Pulaski County Schools
Energy Savings and Performance Contract
Addendum #2
March 25th, 2022

CMTA Contact:	Megan Brangers
Email:	MBrangers@cmta.com
Cell Phone:	502-919-1521

The following information supersedes or is in addition to information released in the Contract Documents dated March 11th, 2022 and addendum 1 dated March 18th, 2022.

M3-4.0

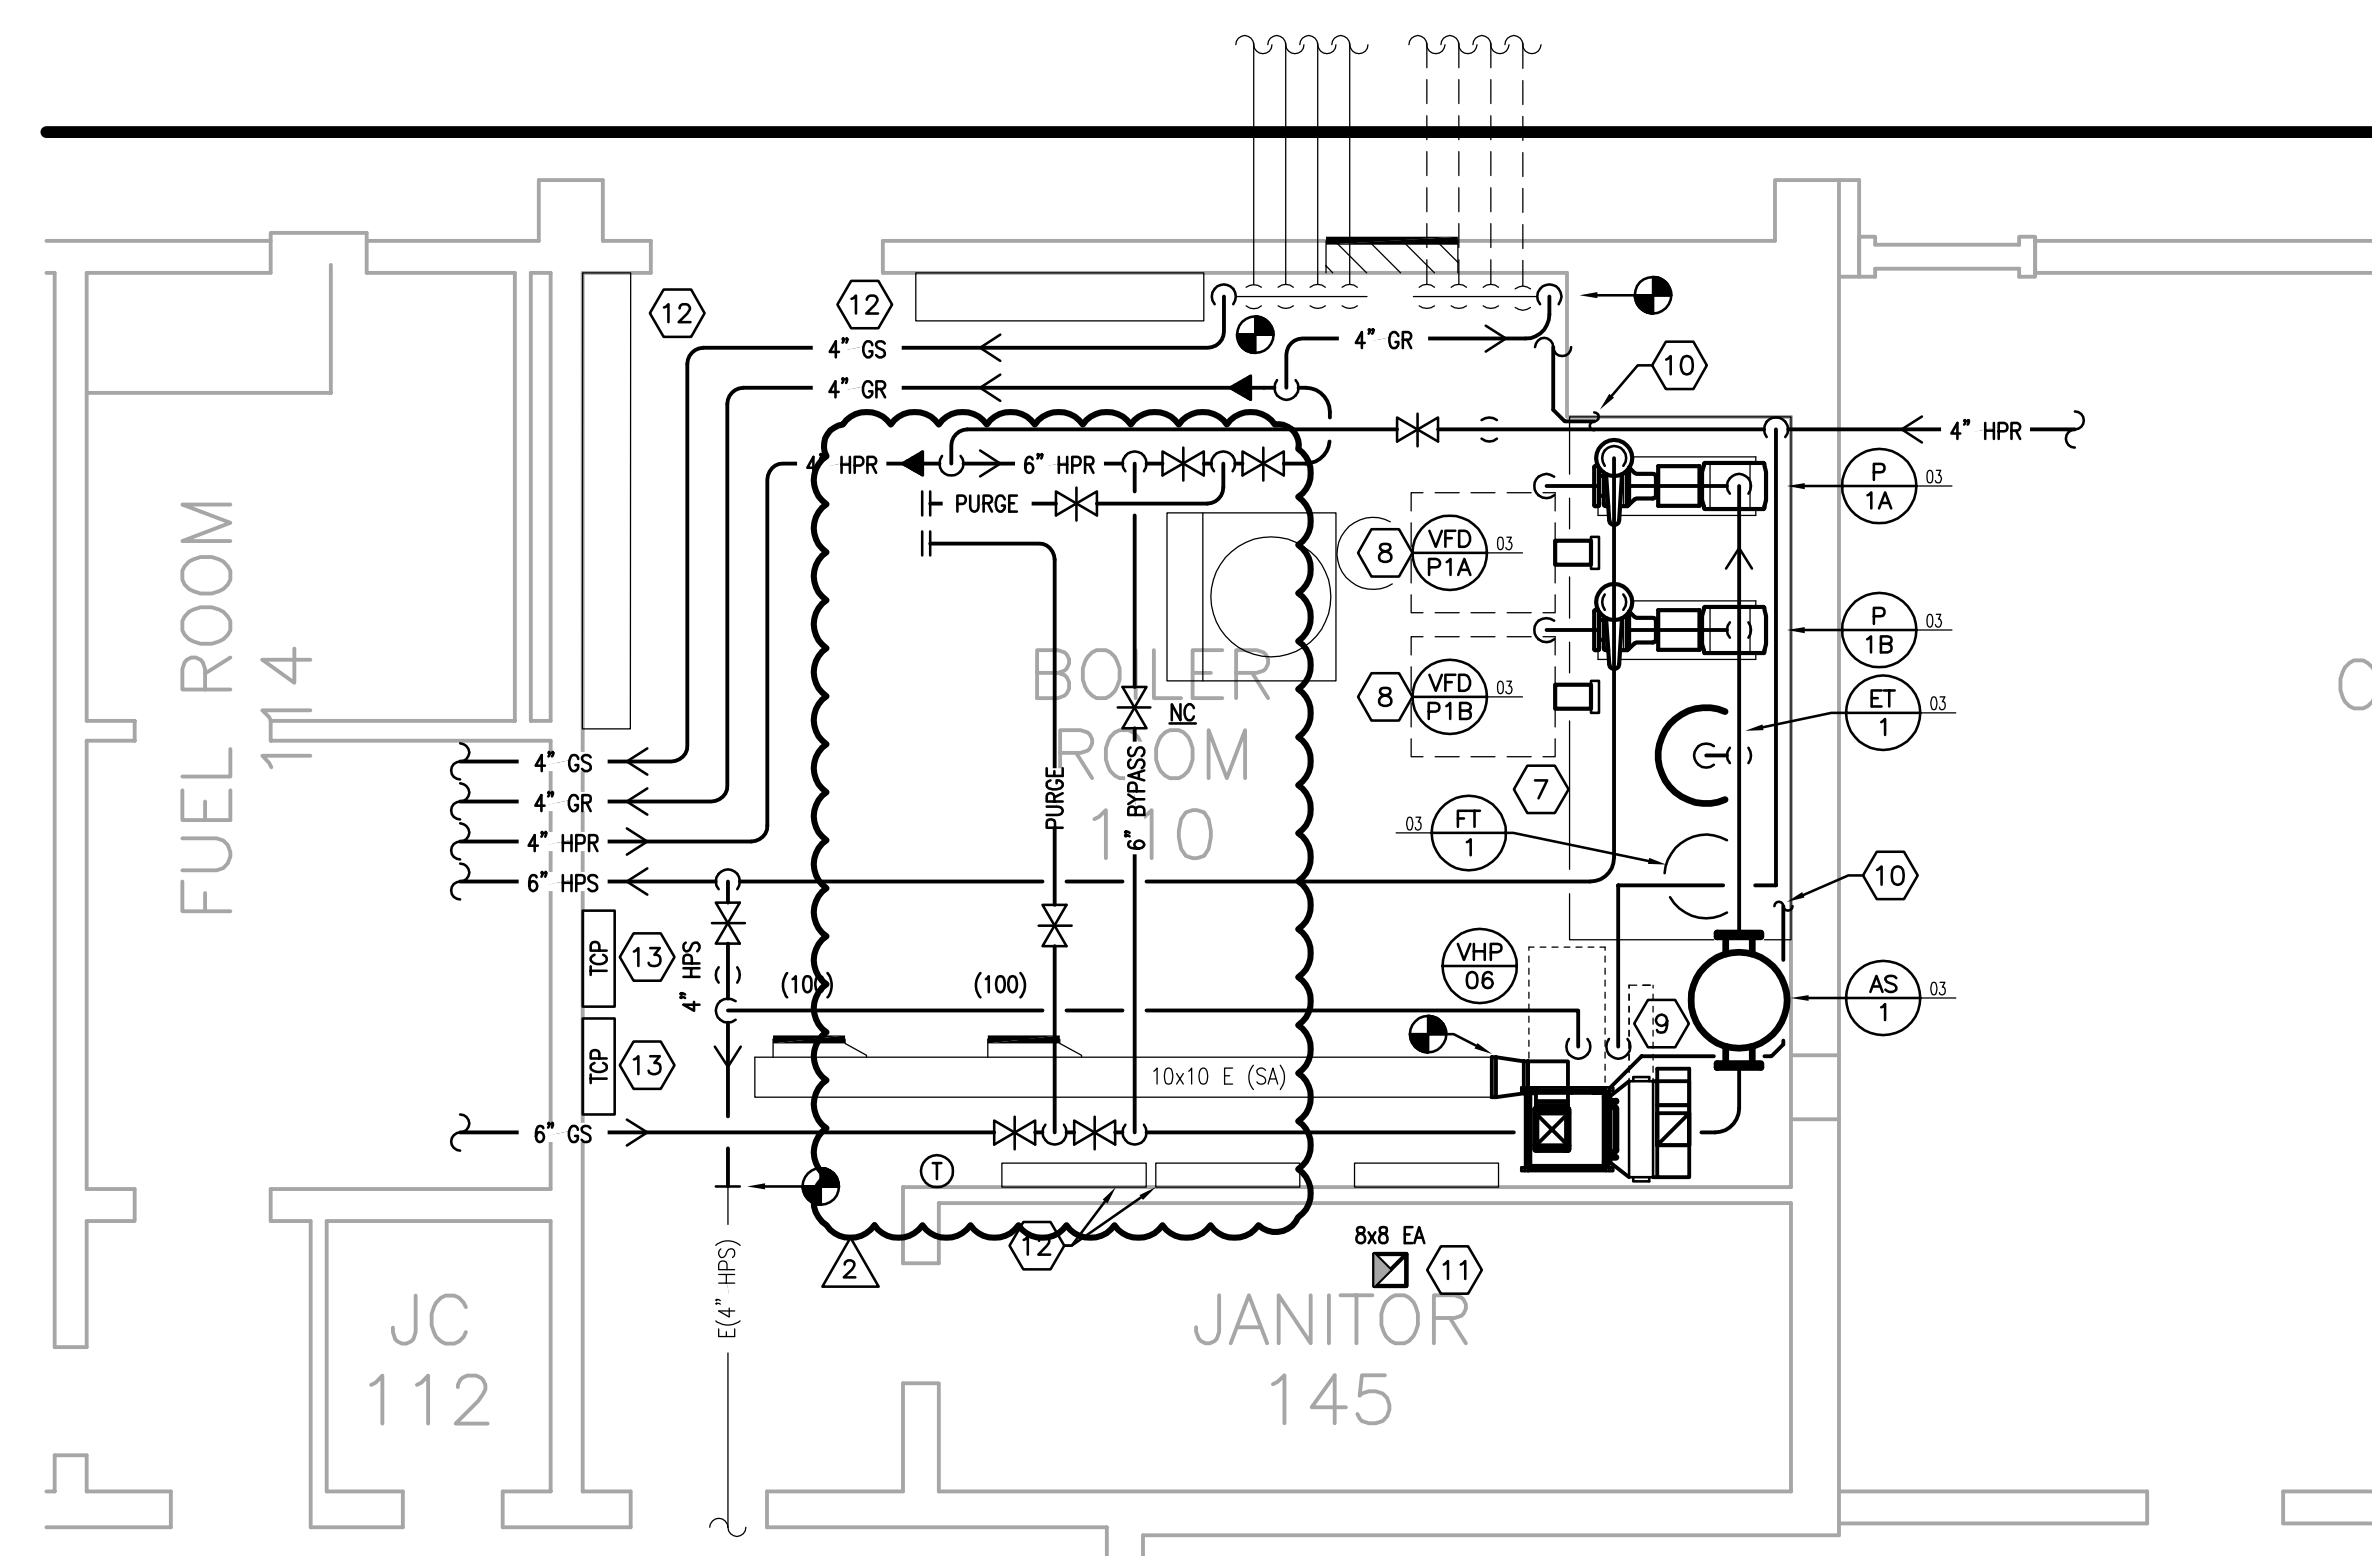
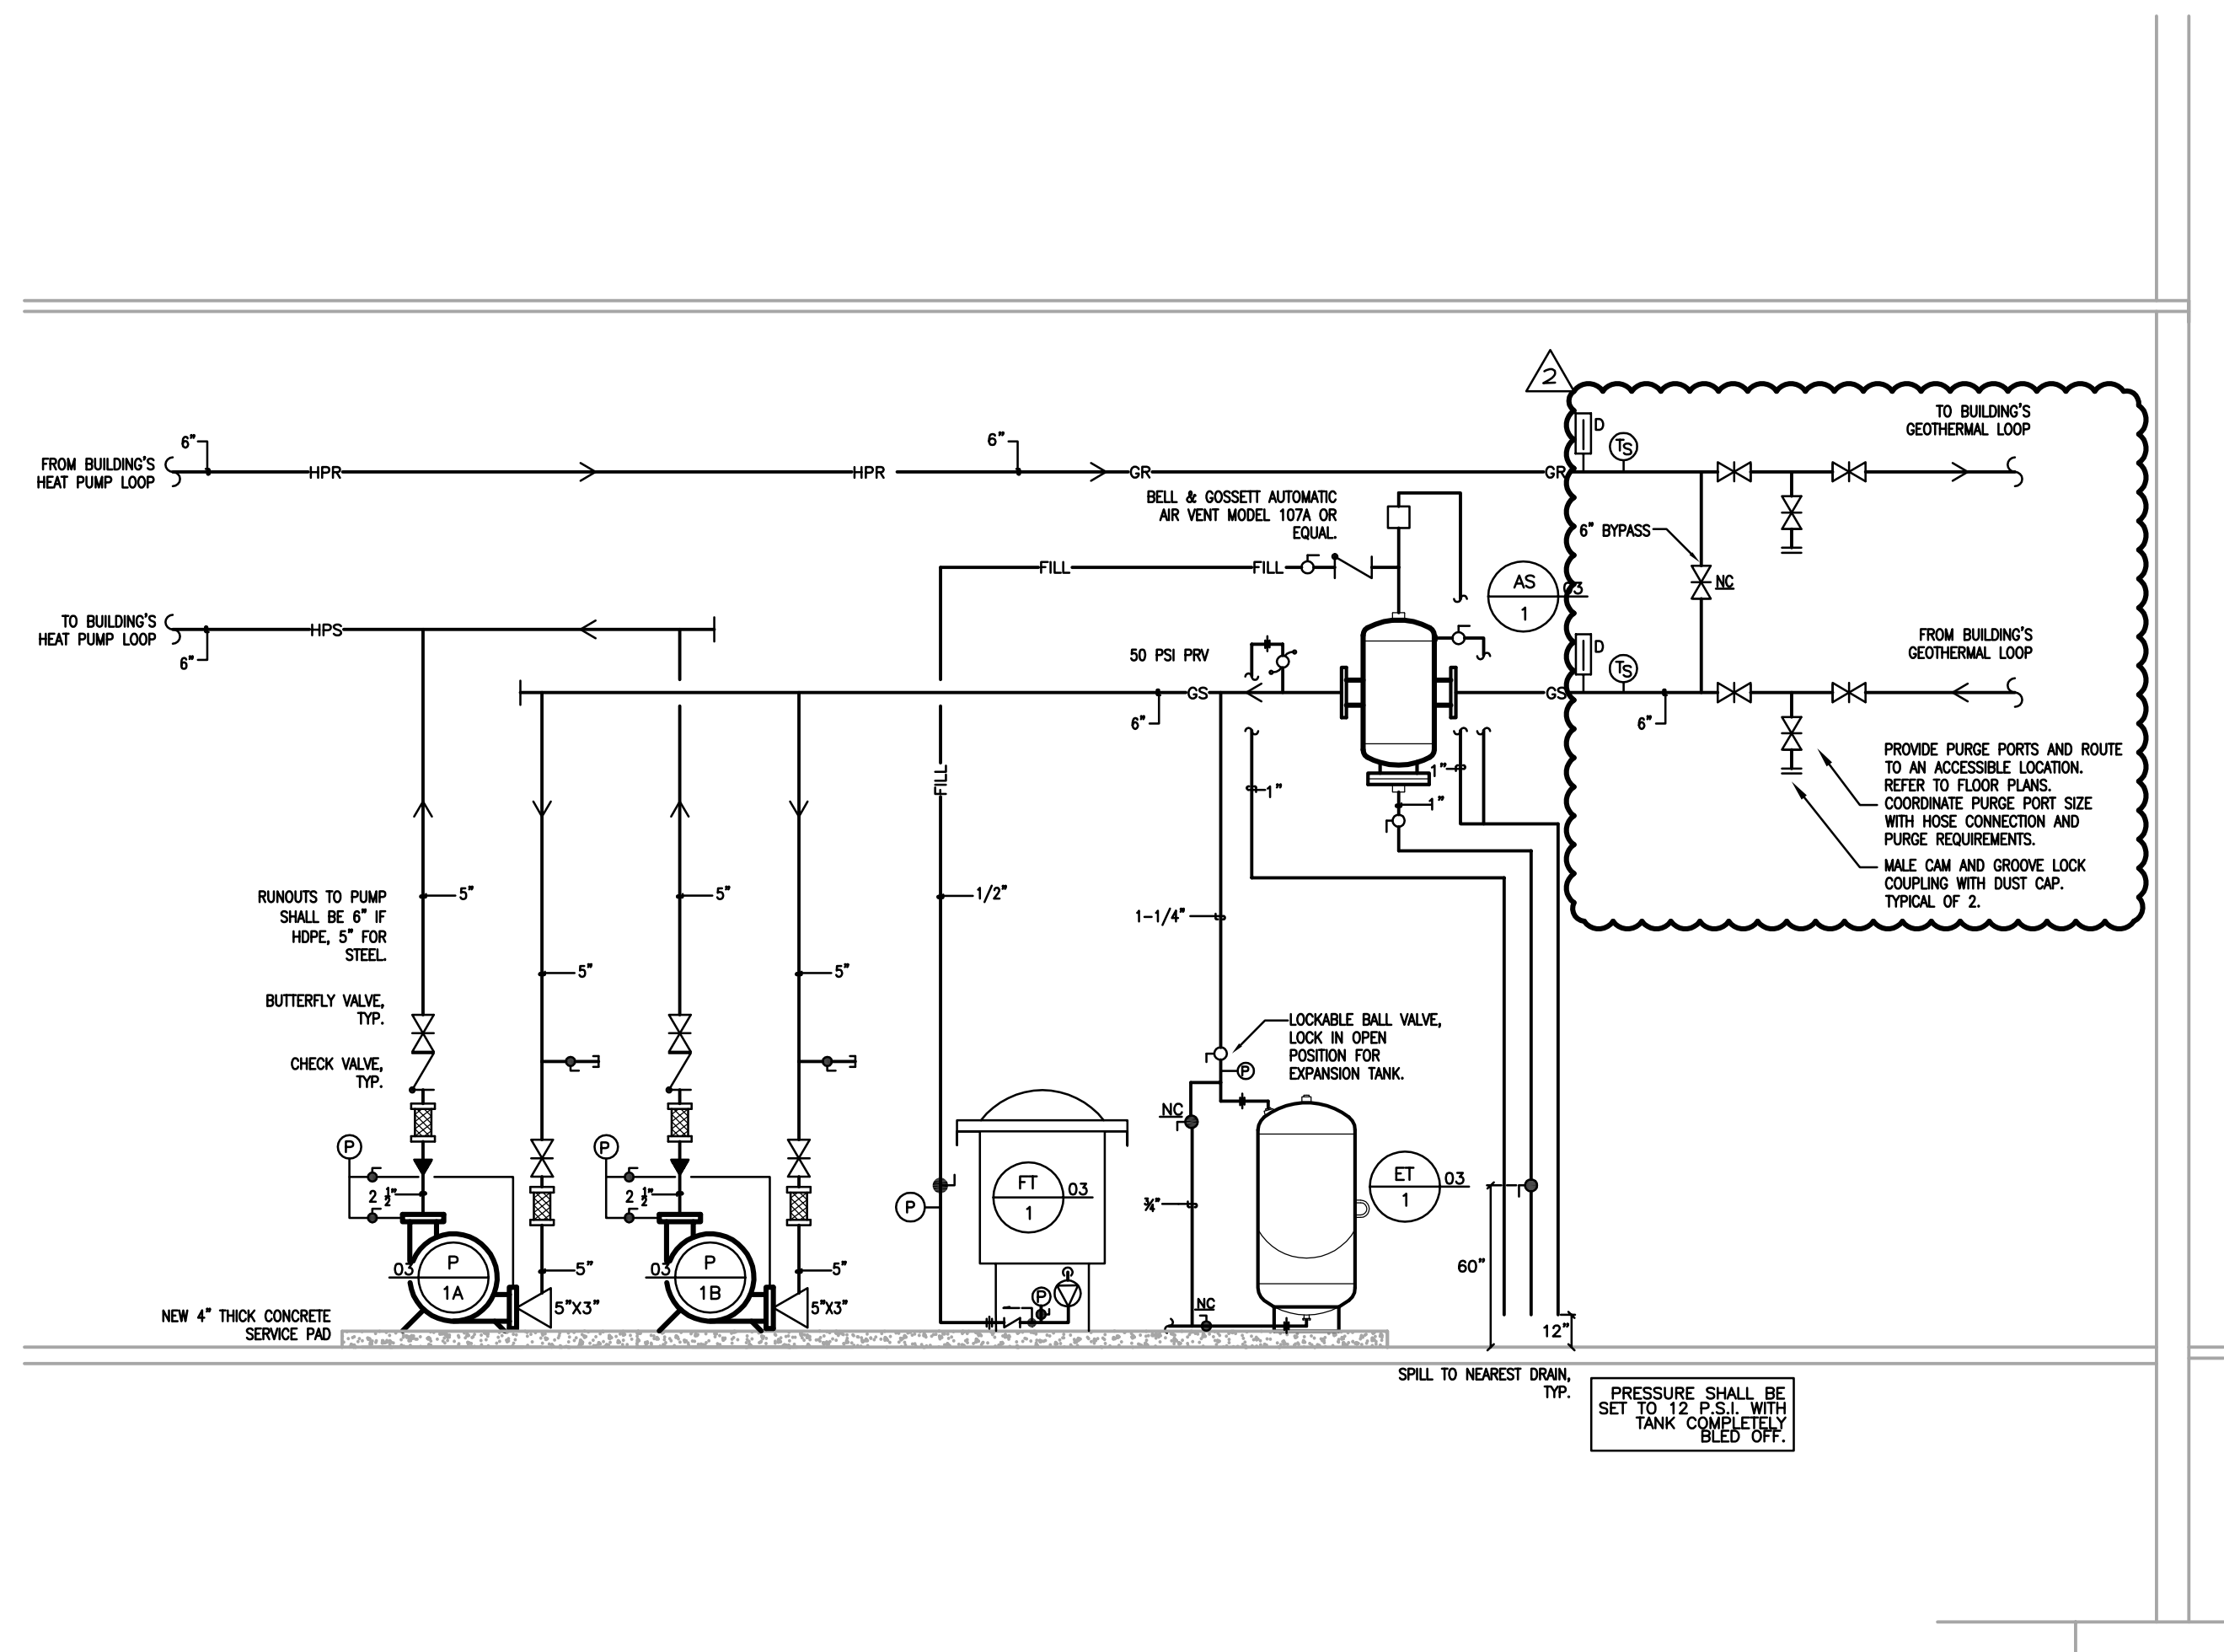
19. Drawing M3-4.0

- a. Refer to Enlarged Boiler Room – Mechanical for revised geothermal and heat pump piping. Add geothermal wellfield bypass and purge ports.
- b. Refer to 'Geothermal Piping Schematic' for updates. Add geothermal wellfield bypass and purge ports.
